SUBJECT: *Part Change (pre-drive, drive transistor) and New PCB Information*

This is information to announce some part changes and PCB update on TS-2000 series.

TS-2000/2000X/B2000 FINAL UNIT X45-360X-XX				
	Status	OLD PCB Rev: J79-0110-09	NEW PCB Rev: J79-0110-19/29	Remark
Q2	Transistor (Pre-Drive)	2SC1971 (non-RoHS) 2SC1971-101 (RoHS)	RD06HHF1-102 (RoHS)	Not compatible
Q3, Q4	Transistor (Drive)	2SC1972-26 (non-RoHS) 2SC1971-126 (RoHS)	RD16HHF1-102 (RoHS)	Not compatible

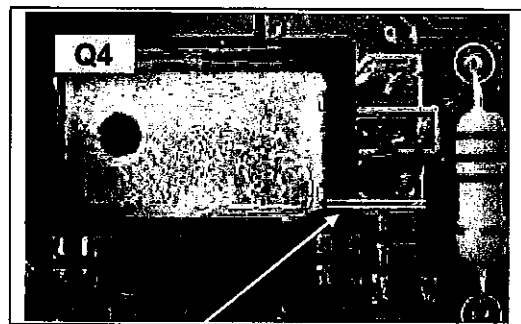
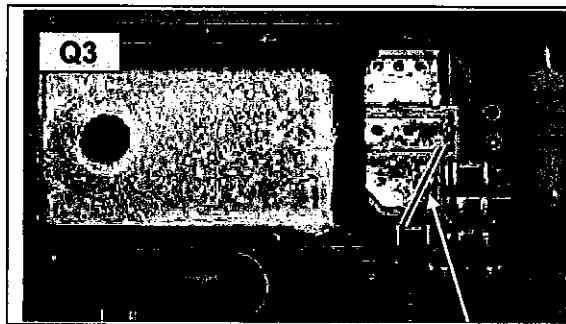
On the newer final units J79-0110-19 onwards, 1 ohm resistor RK73RB2E1R0J is added in series to RD16HHF1-102 gate terminal. However, only on the PC board J79-0110-19, the solder pad for this 1 ohm resistor is not available. If you need to replace drive transistor RD16HHF1-102 on the PC board J79-0110-19, the following modification is required to add 1 ohm resistors.

1. Cut only the gate terminal in 3mm length

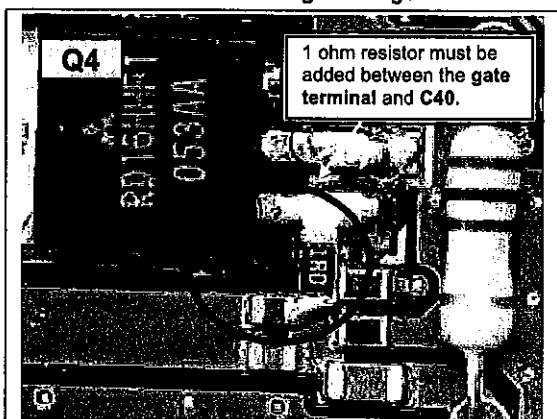
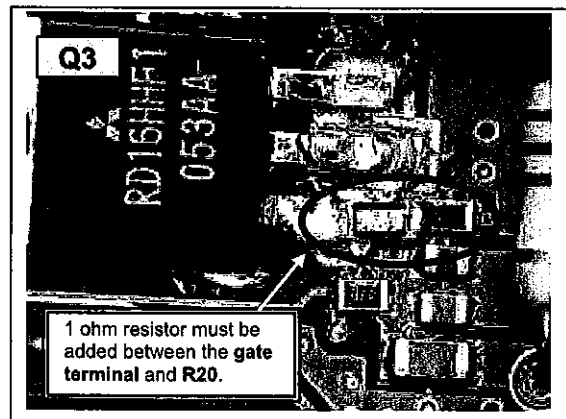
2. Remove the defective drive transistor from PC board.

The solder pads for gate terminal have already been cut at the factory.

3. Mount drive transistor RD16HHF1-102 and 1 ohm resistor RK73EB2E1R0J as following drawings.

<NOTICE FOR REPLACING FINAL UNIT X45-360>

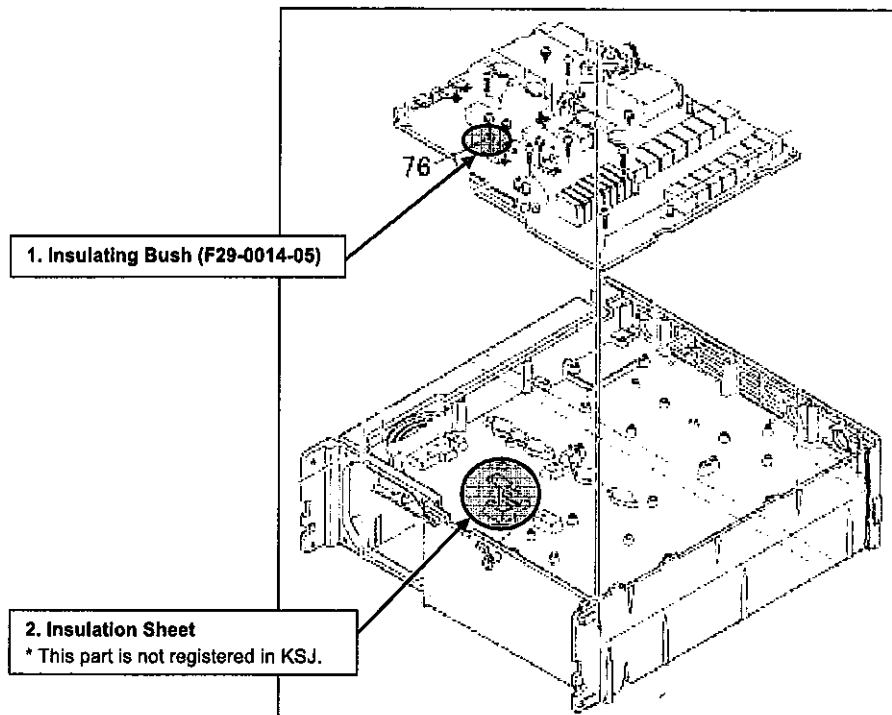
If you replace Final Unit X45-360 with newer revision PC board (J79-0110-19 or higher), 2 parts need to be removed away. One is the insulating bush **F29-0014-05** (Ref No. 76) applied to the screw for pre-drive. Another is the insulation sheet stuck to pre-drive (Q2) area of the chassis. These 2 parts are required **ONLY** for older pre-drive transistor **2SC1971-101**.

After removing the insulation sheet, please apply silicon grease between **RD06HHF1-102** and chassis.
